SR 141/Bethelview Road @ SR 9 (Atlanta Highway) Intersection Improvements

CSSTP-0007-00(999), P.I. No. 0007999
Forsyth County, Georgia

Value Engineering Study Report

September 2009

ALT. NO.
G-1/ROW-4
Sheet 2 of 7

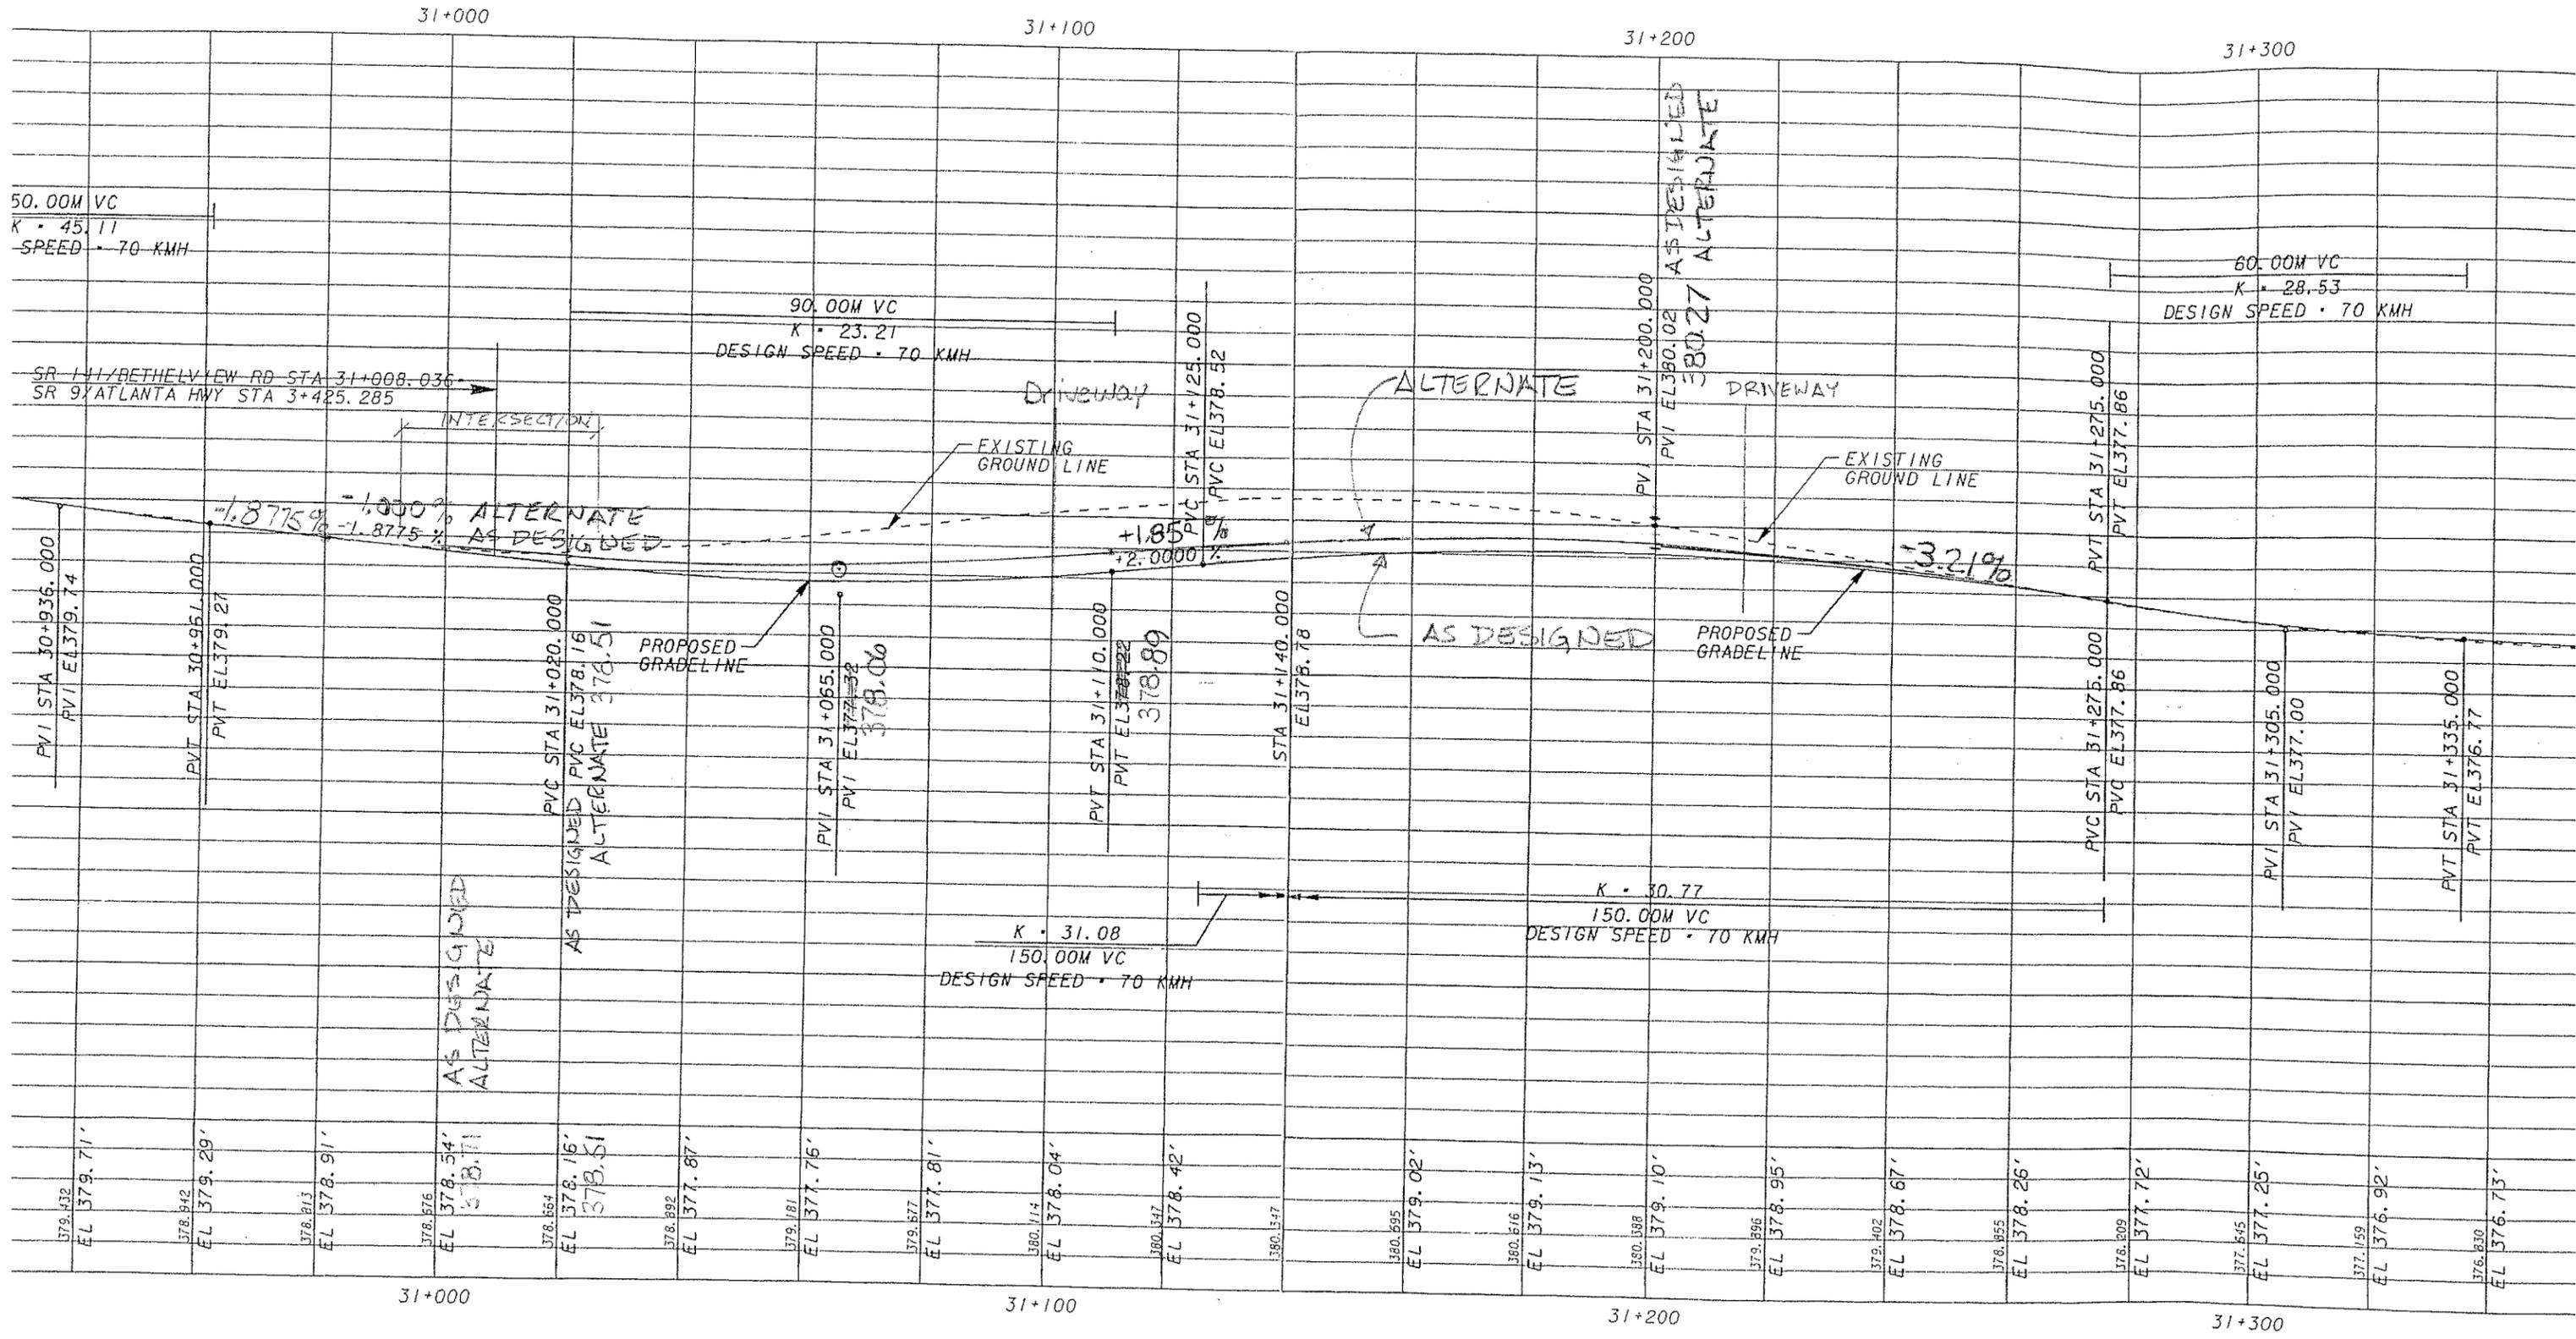
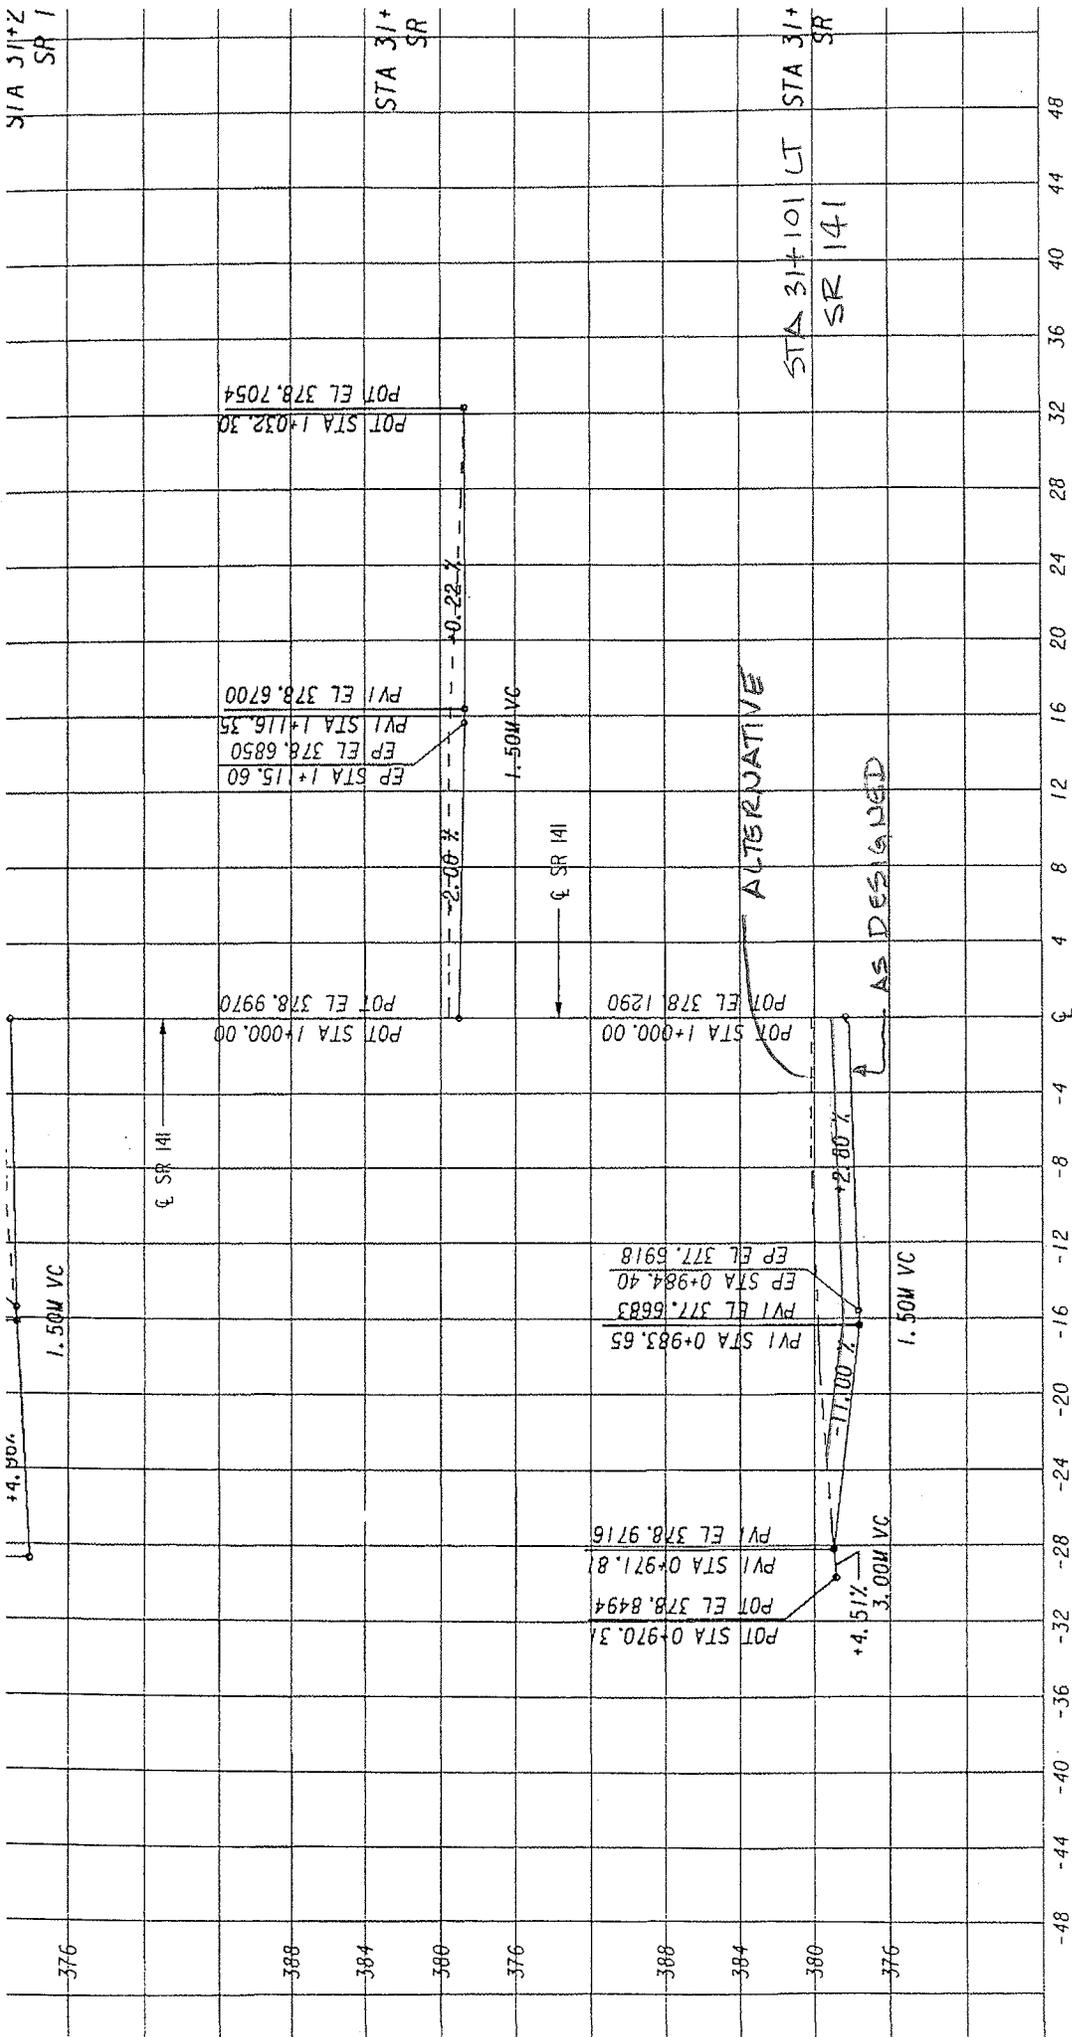
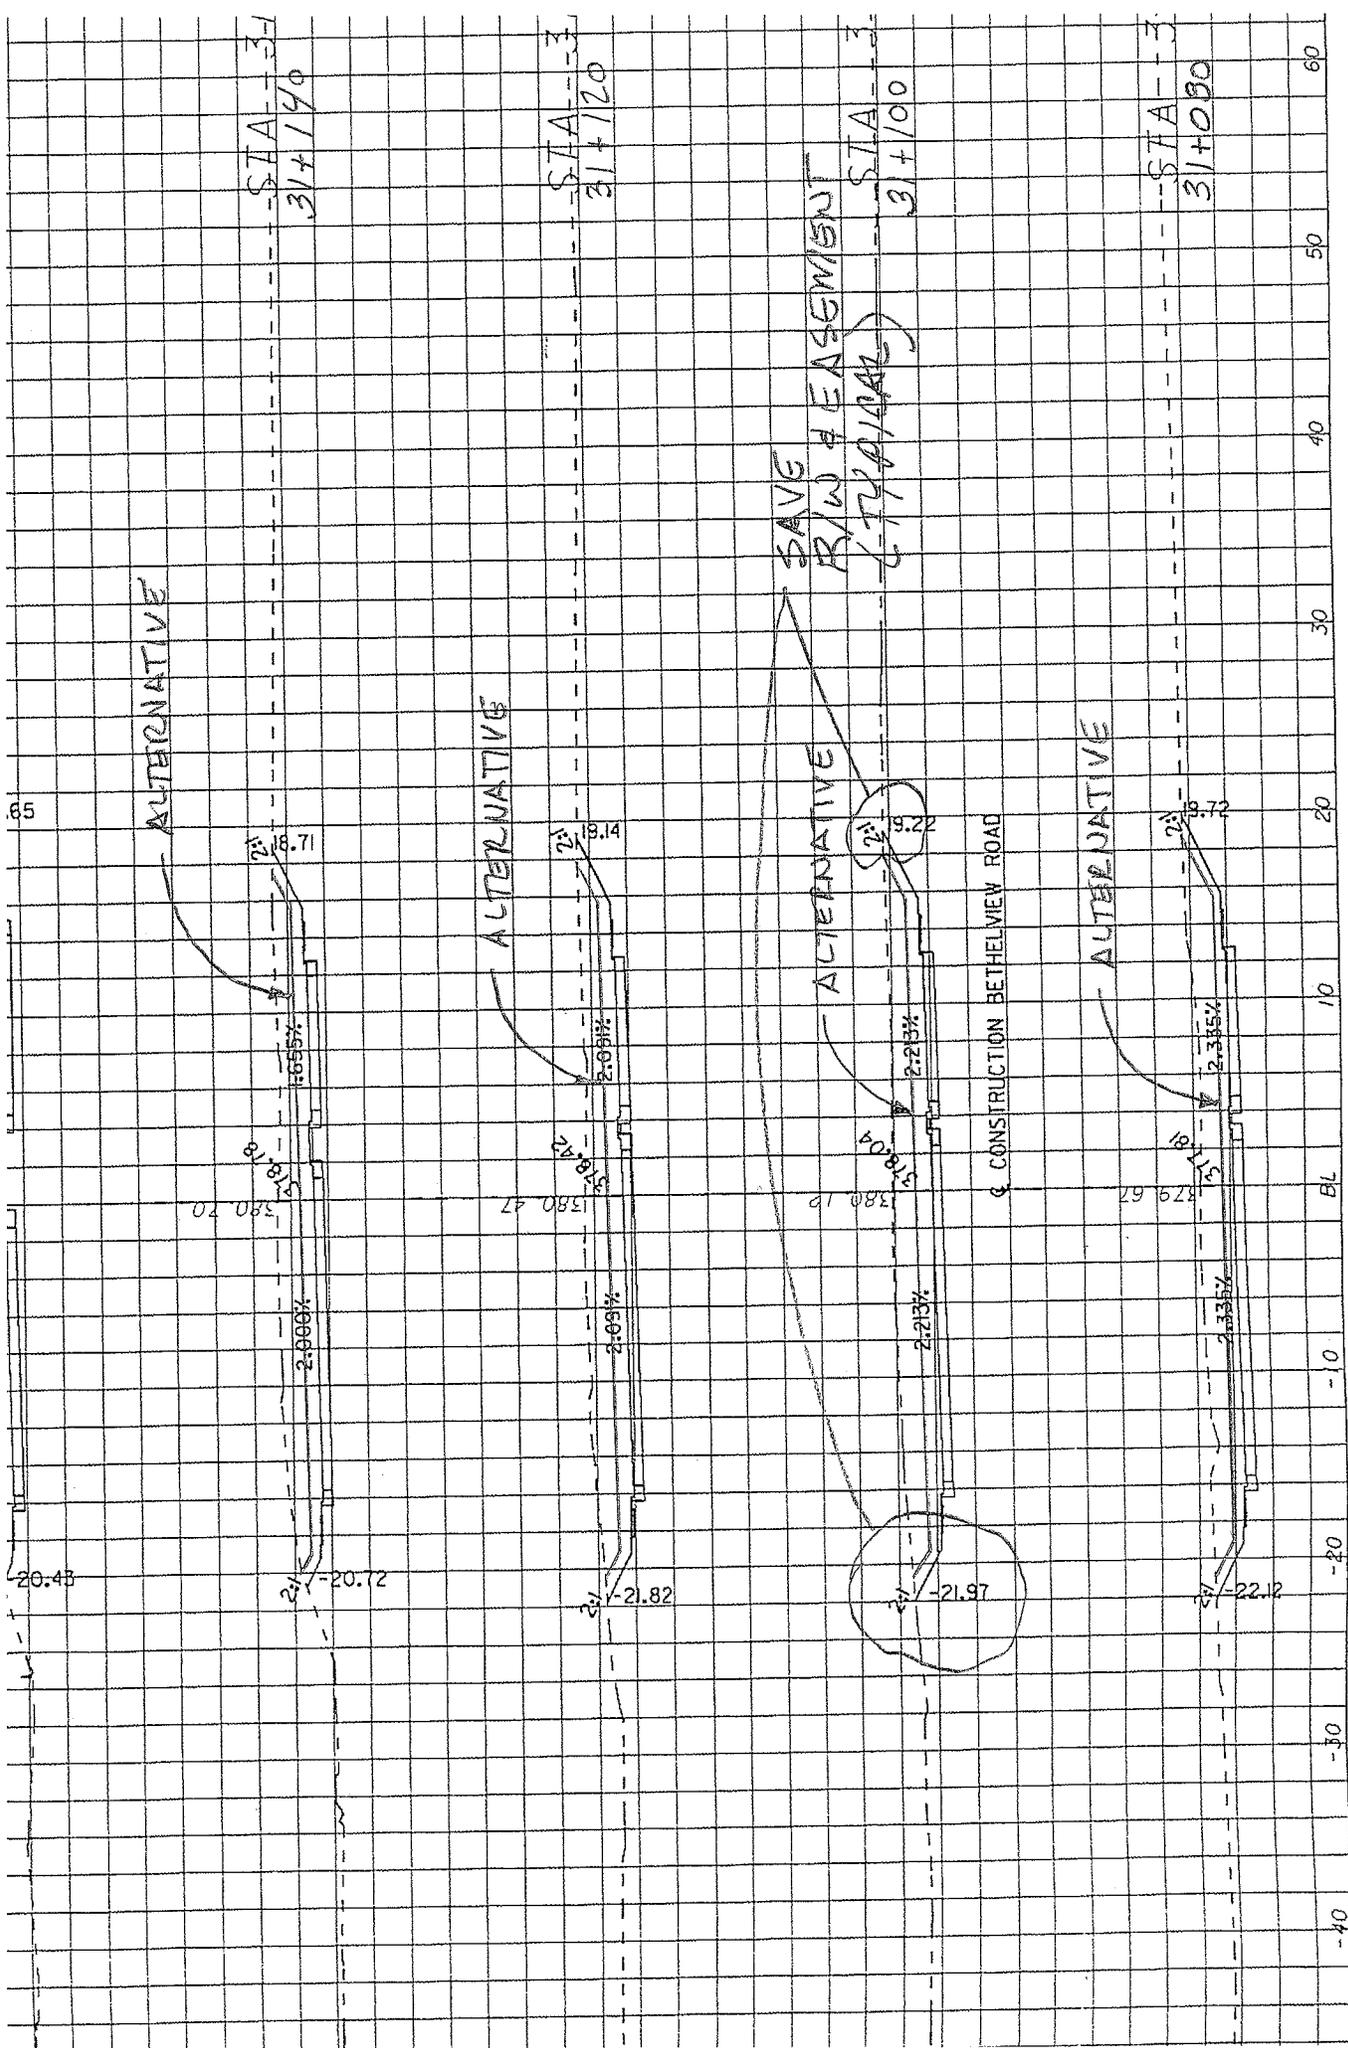
- Reduces right-of-way impacts
- Reduces earthwork needed
- Modifies driveway to Parcel #155A to avoid major improvements

Raising the profile and reducing the cut within the station limits will eliminate the right-of-way limits needed at Parcel #155 as well as reduce earthwork requirements.
